ISSUE	DATE	REVISION
A	16/11/22	DA Submission
B	06/03/23	RFI
C	27/09/23	LEC
D	08/11/23	LEC
E	21/11/23	LEC
F	29/01/24	Amended Issue for LEC

PROJECT
Terrace Houses

ADDRESS
2-6 Martin St, Roselands NSW 2196 Australia

North Elevation

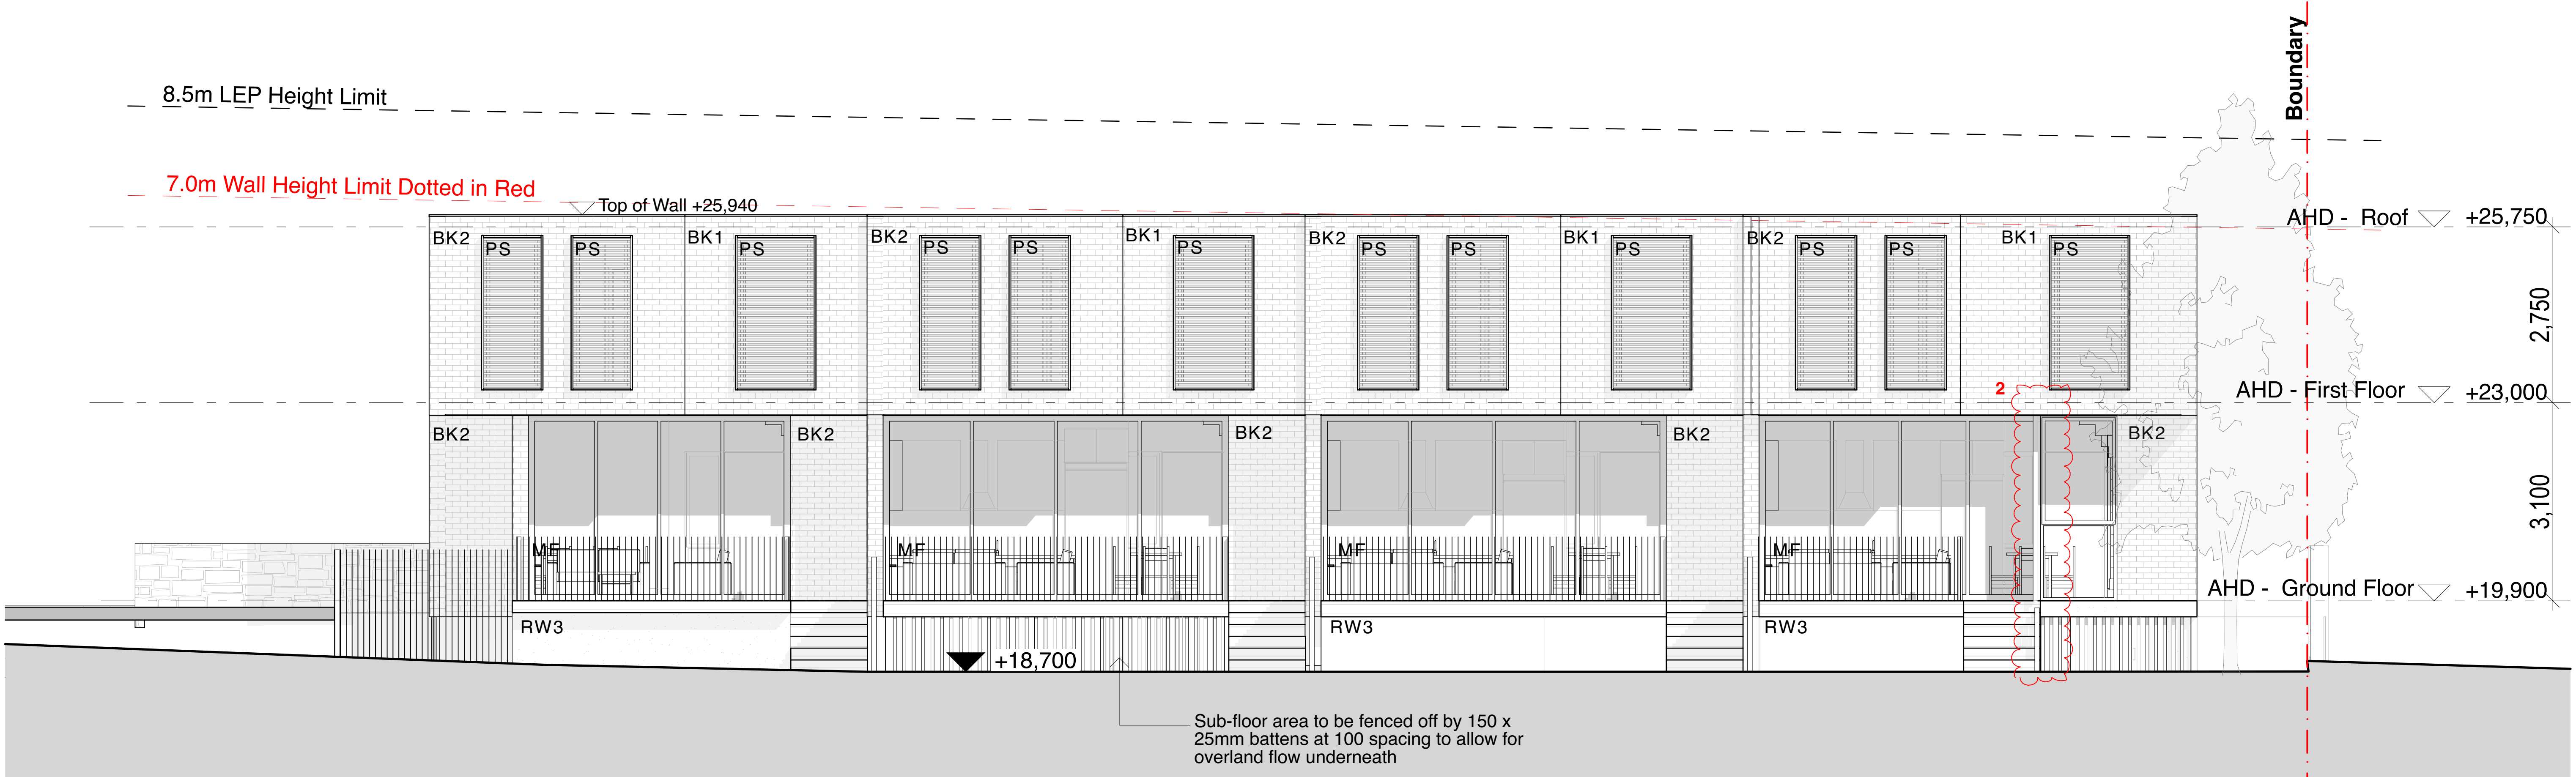
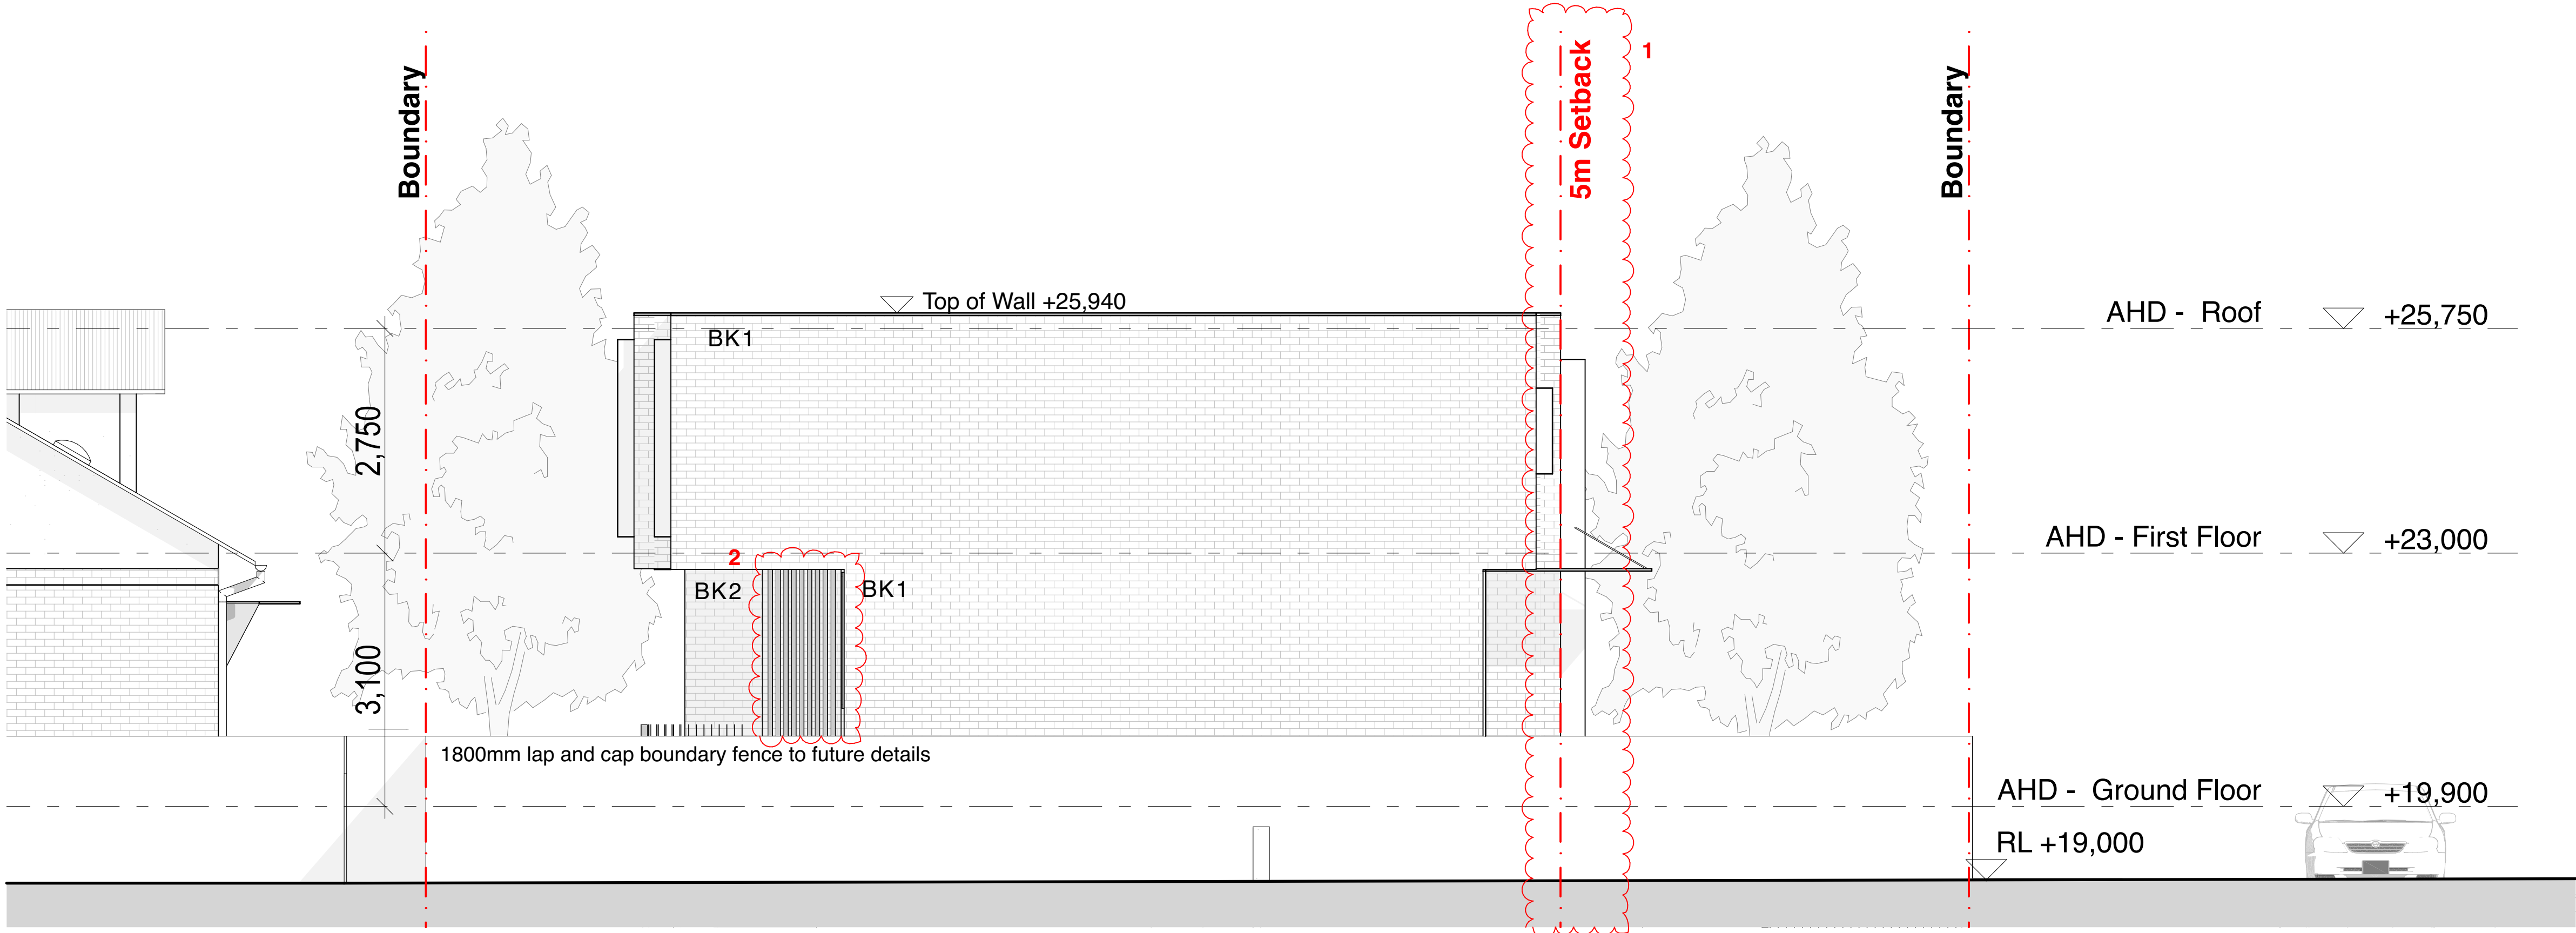
- AMENDMENTS:**
1. Building setback increased to 5m.
 2. Slatted privacy screen added to Unit 1C. Slats angled away from neighbouring property.

Section A-A

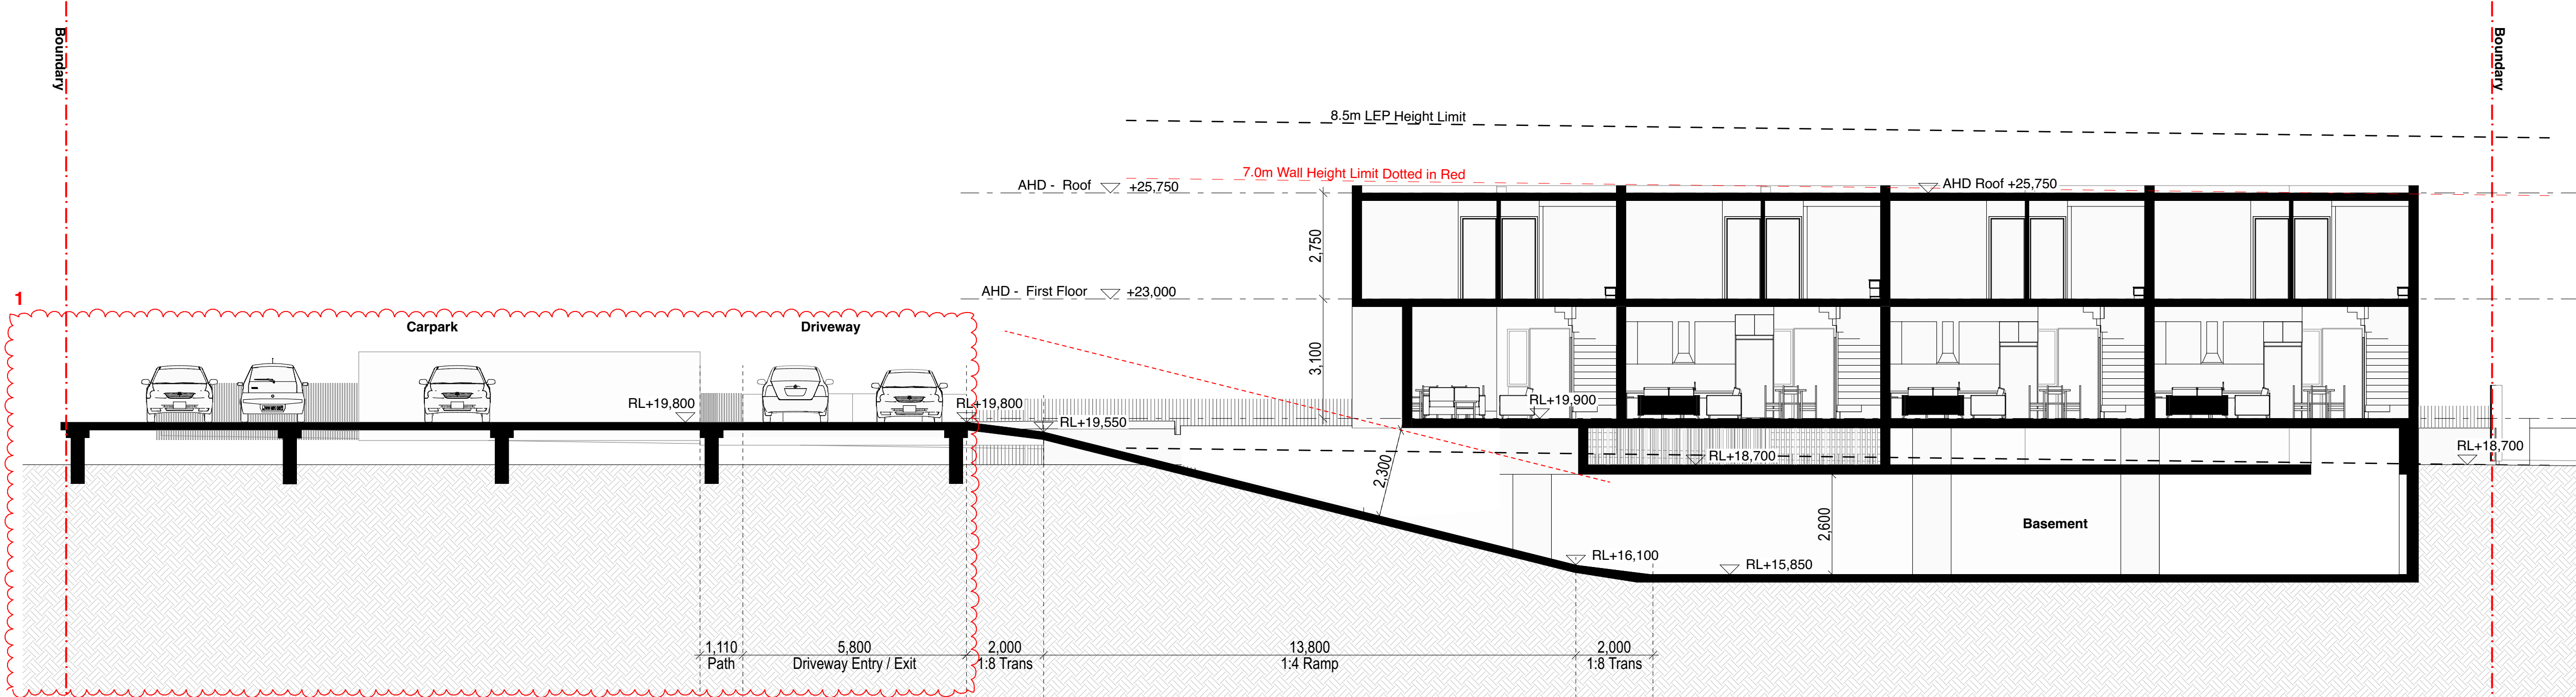
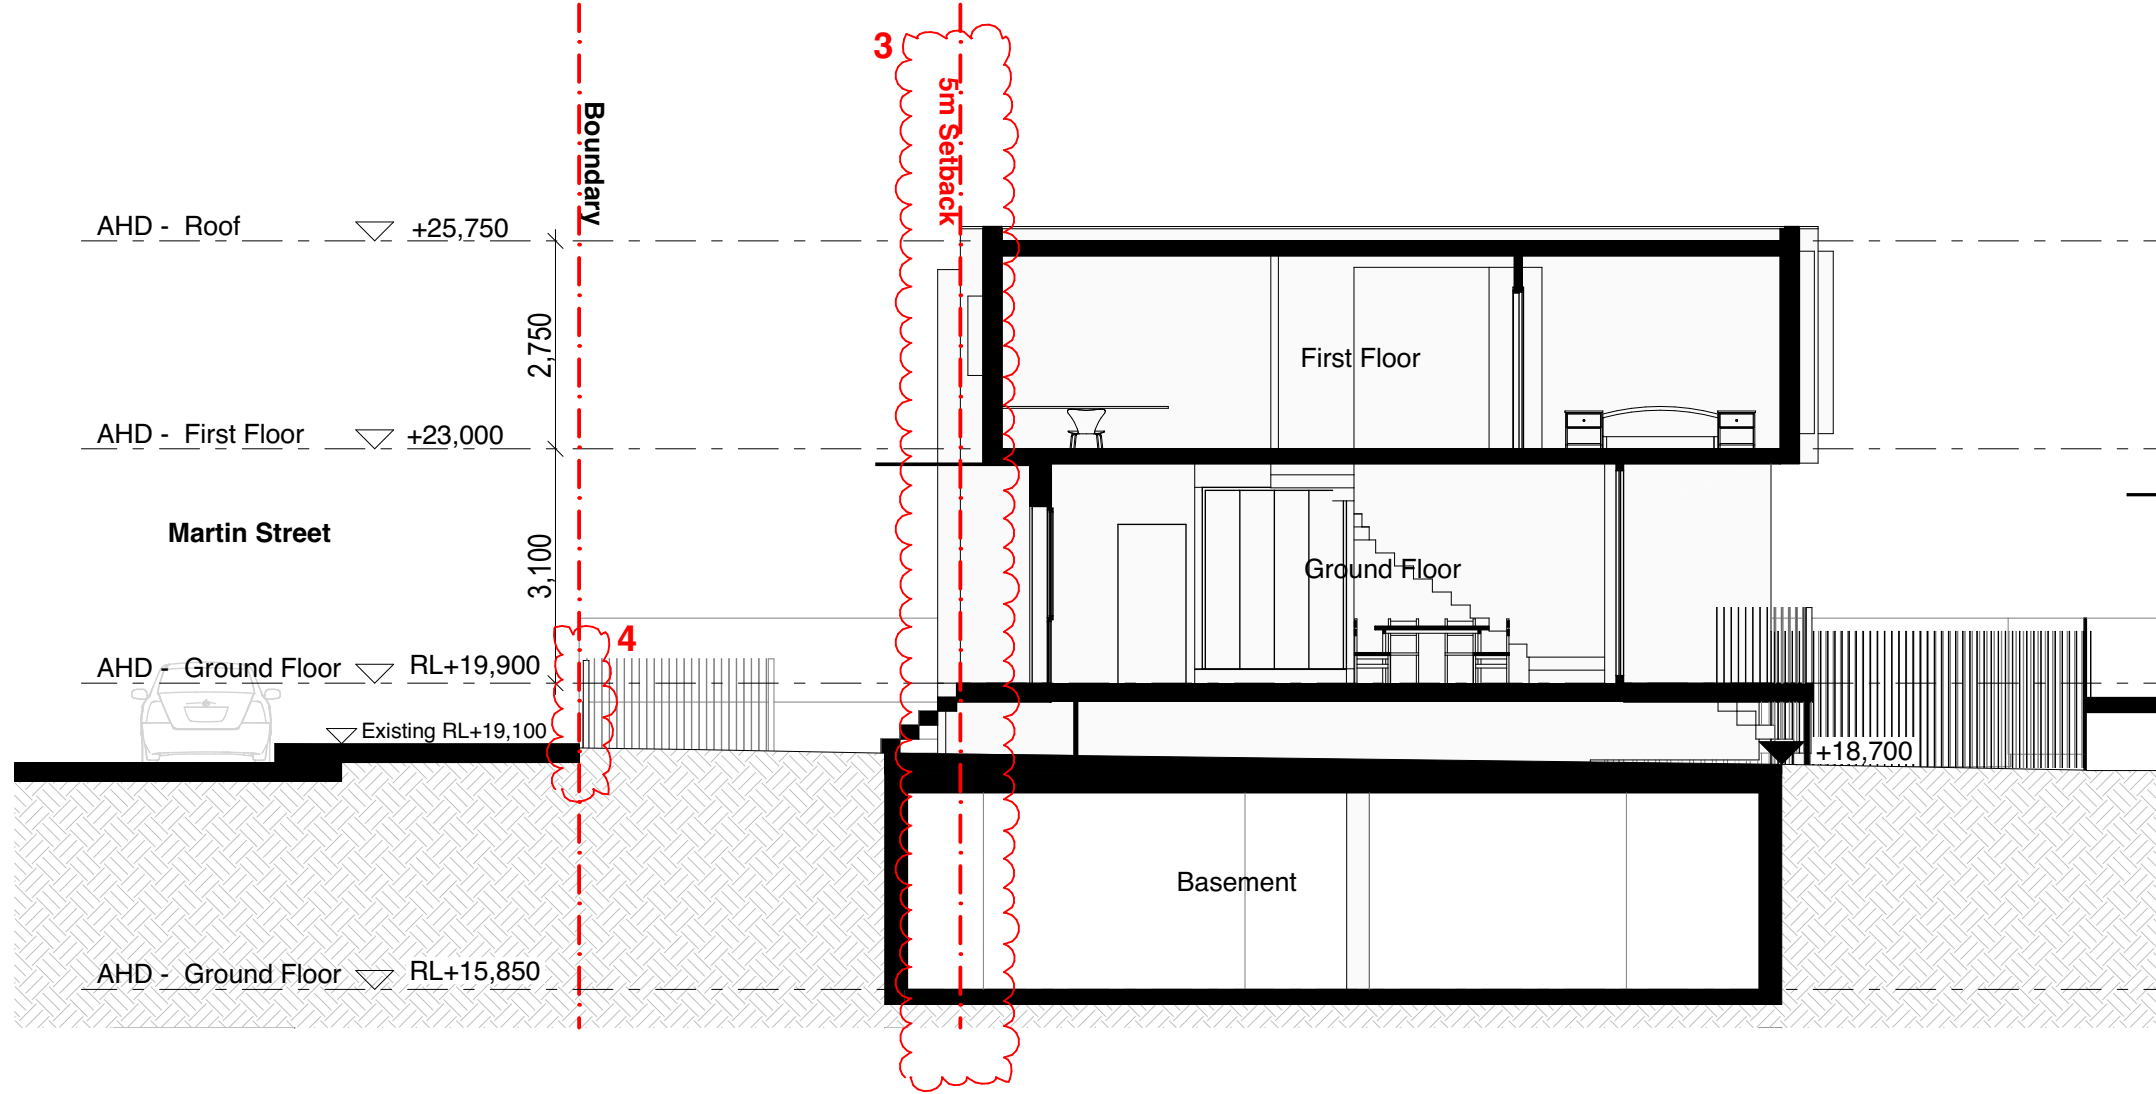
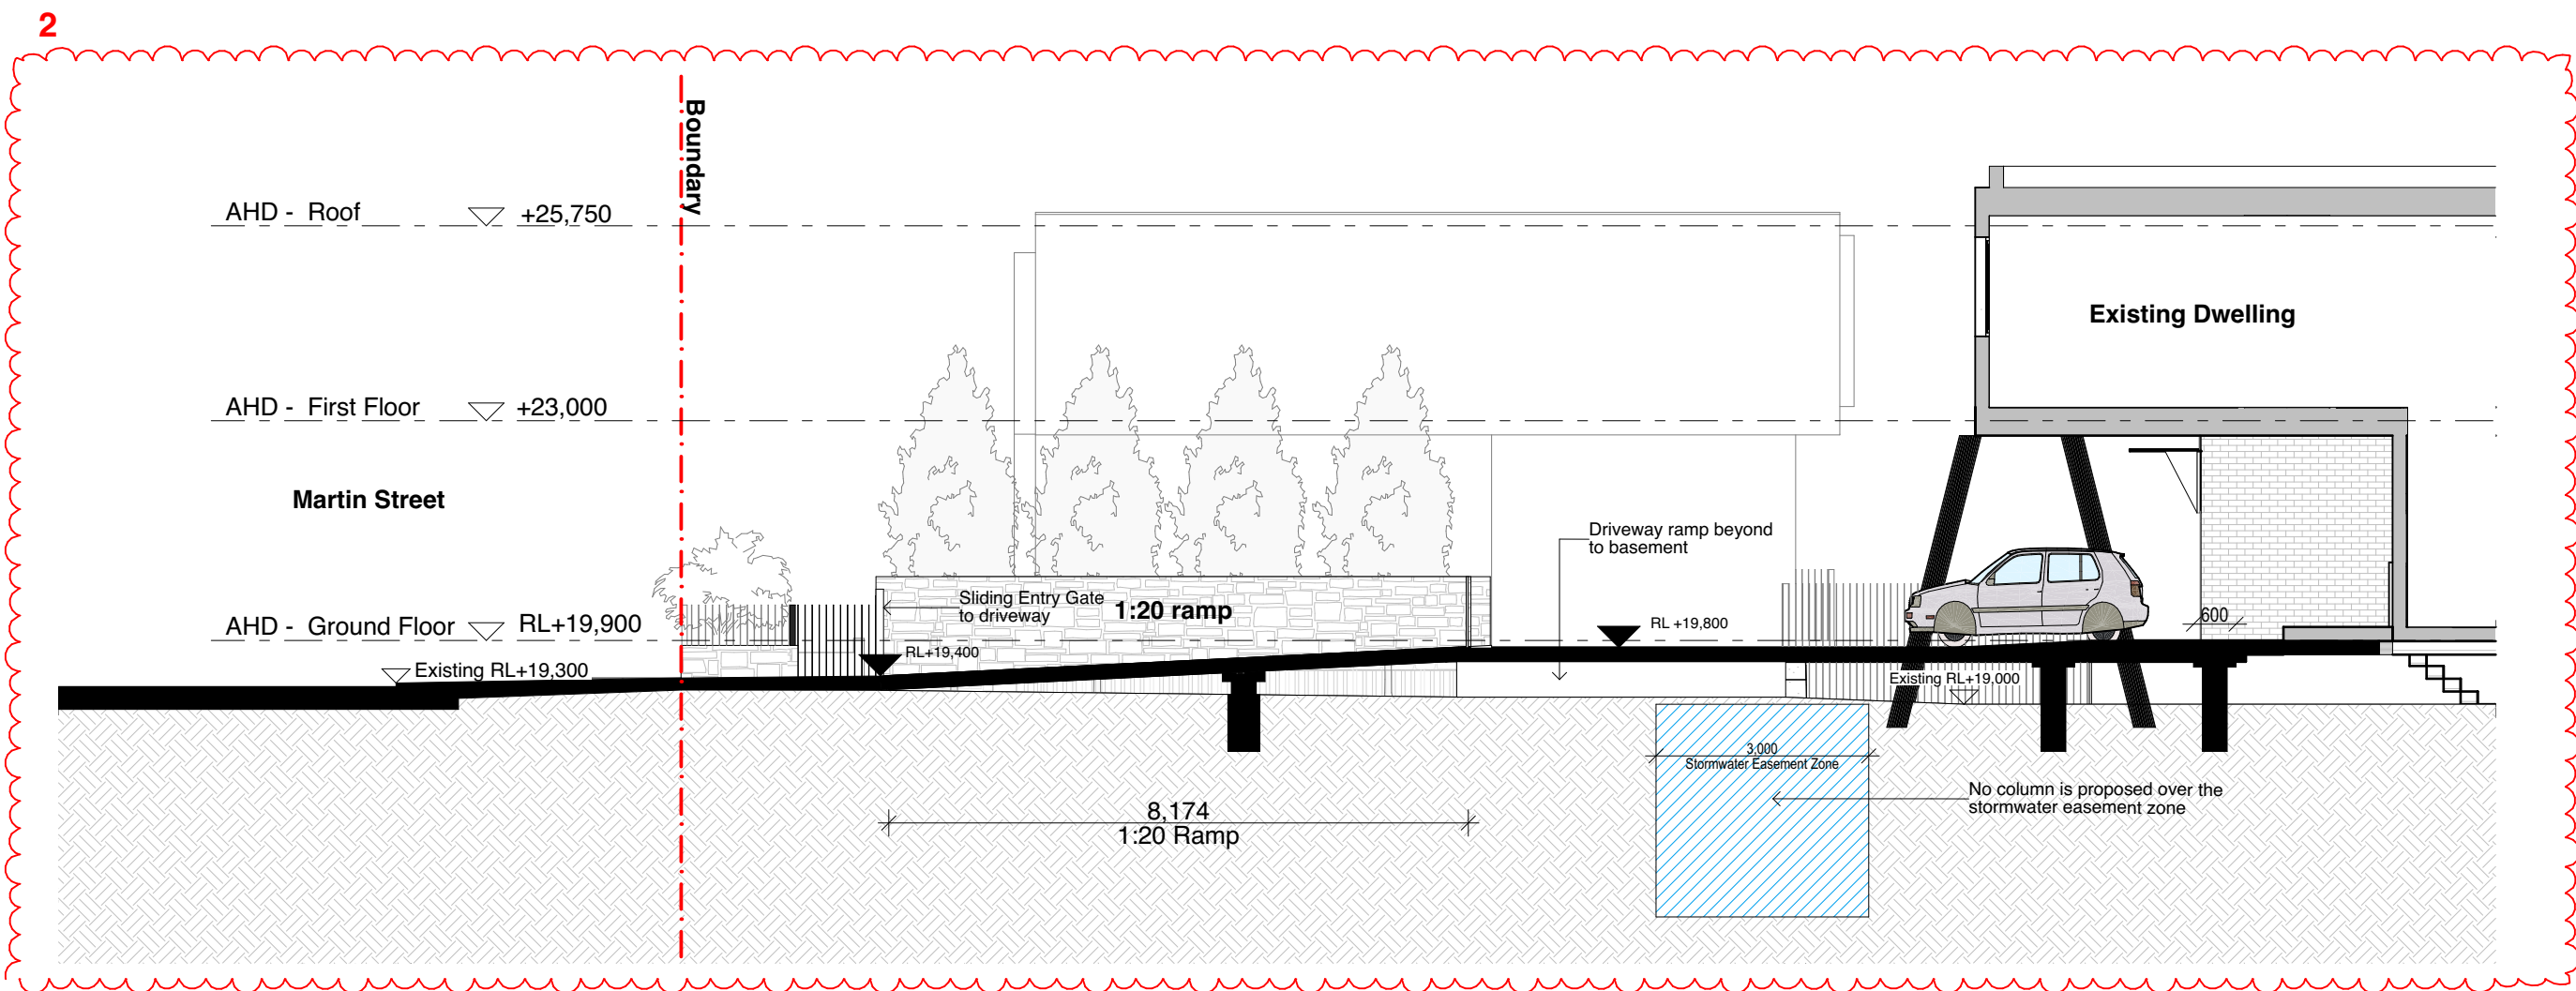
- AMENDMENTS:**
- 1. Additional information added to longitudinal section. Section includes driveway and carpark area.
 - 2. Section updated to show driveway crossing at boundary.
 - 3. Building setback increased to 5m.
 - 4. Front fence height amended to max 1.2m high.
